International Aero Engines

SERVICE BULLETIN

ENGINE FUEL AND CONTROL - FUEL SYSTEM AIR TUBES - INTRODUCTION OF REVISED EEC
PIPE-SUPPORT BRACKET

V2500-ENG-73-0140

View of Fuel Systems Air-Tubes Bracket - Before alteration
Figure 1

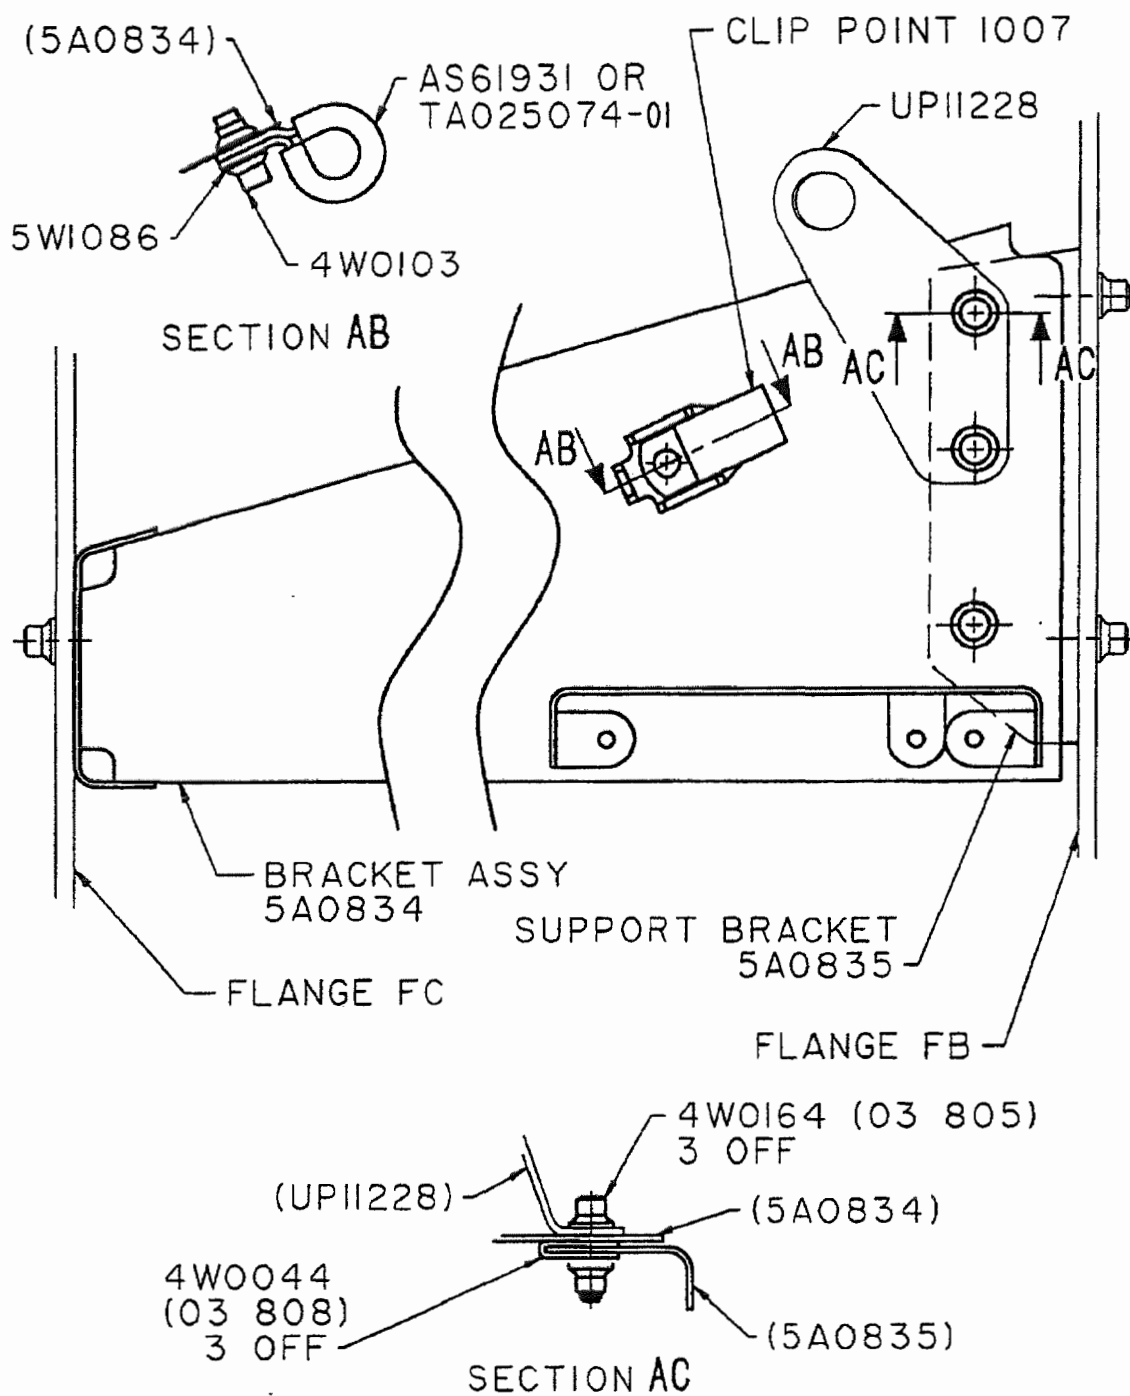
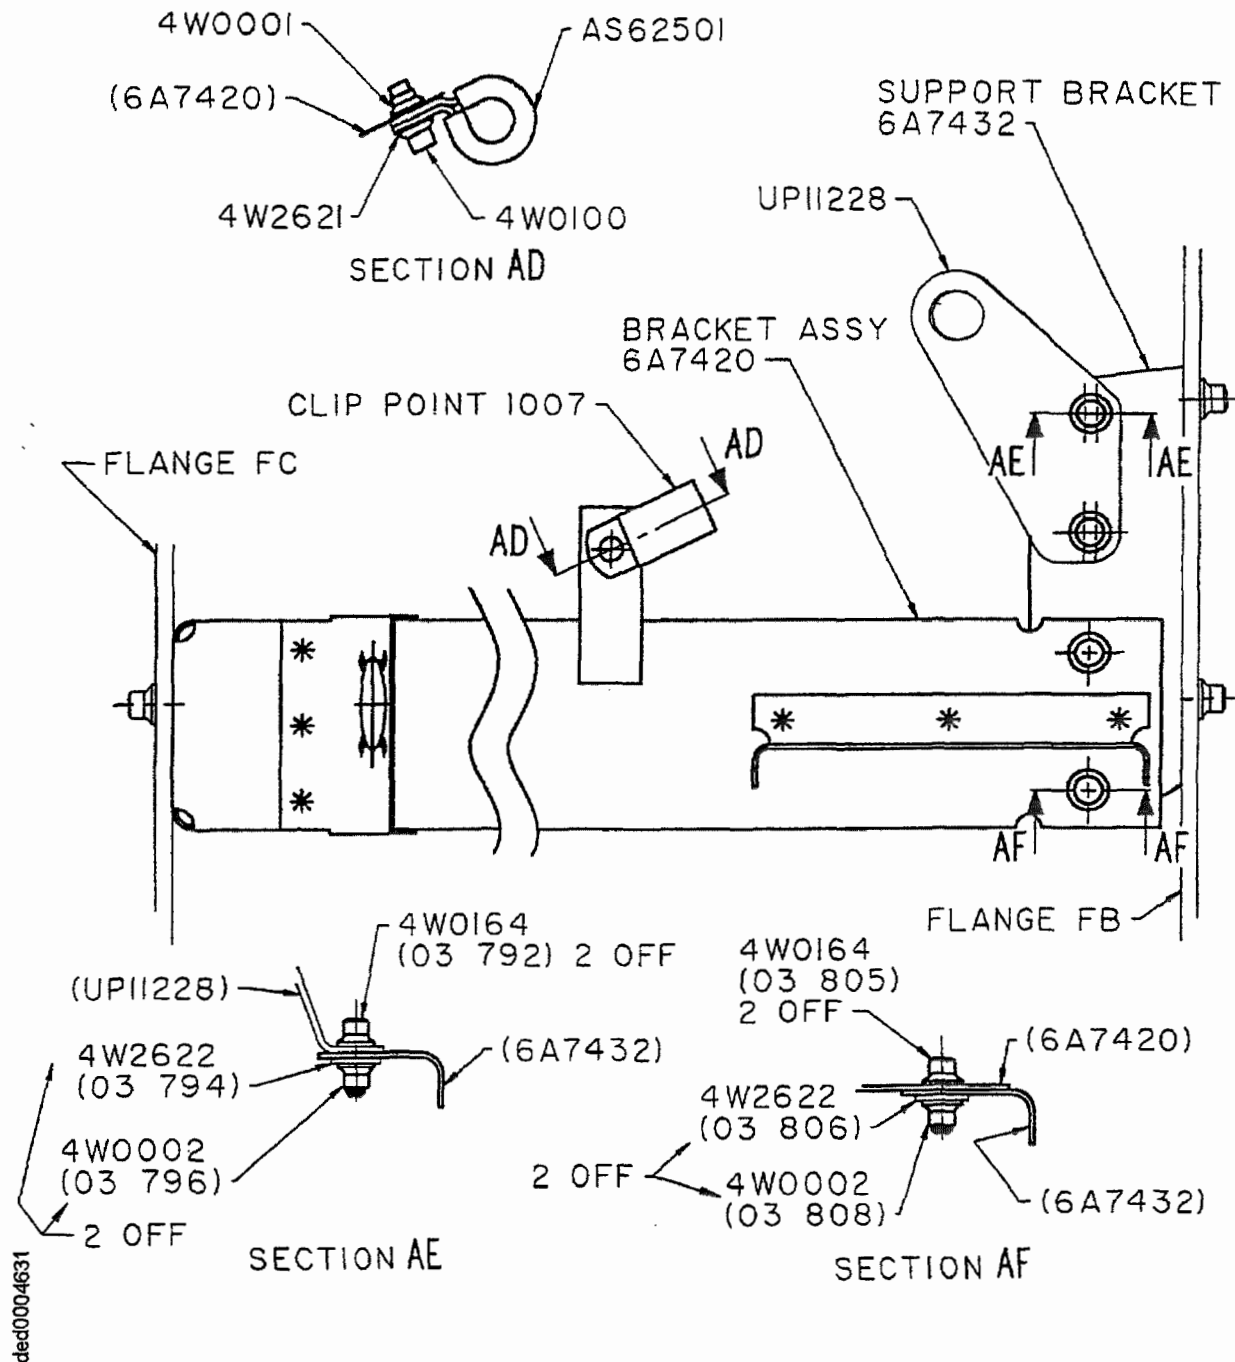
- (2) The EEC Pipe-support bracket has been revised, the changes introduced are as follows:
 - (a) The method of manufacture has changed. The component is fabricated by spot and fillet welding, not rivets which are deleted.

- (b) The material has changed from Titanium (TCA) to Stainless Steel (EBM).
 - (c) The profile of the bracket has changed from triangular to rectangular.

- (d) Due to the profile change the anti-rotation lug and anchor nut used to attach clip point CP1007 has been deleted and an additional Spur-bracket has been welded on.

- (e) The number of holes for attaching the L-Shaped fixing bracket at flange FB have decreased from three to two. In addition, the slots have been changed to holes.

- (3) A revised L-Shaped fixing bracket is introduced, the changes are as follows:
 - (a) The material is changed from Titanium (TCA) to Stainless Steel (EBM).

- (b) The number of holes on the support face has been increased from three to four, two for the revised EEC Pipe-support bracket and two for the existing UP11228 bracket. In addition, the holes have been changed to slots.

- (c) To make the manufacture easier, minor changes have been made to the geometry and profile of the bracket.
- (4) The quantity of fasteners that attach the EEC Pipe-support bracket to the L-Shaped fixing bracket have decreased from three to two. In addition, as the holes have changed to slots, washers have been introduced. The nut has changed from a clip nut to a standard nut.

- (5) The fasteners that attach the existing bracket (UP11228) also attach the EEC Pipe-support bracket. As bracket UP11228 is attached to the L-Shaped fixing bracket two separate nuts, bolts and washers are introduced.

- (6) Clip Point CP1007 has a revised washer and the clip nut is changed to a standard nut. The opportunity has been taken to revise the clip in line with current design practices.
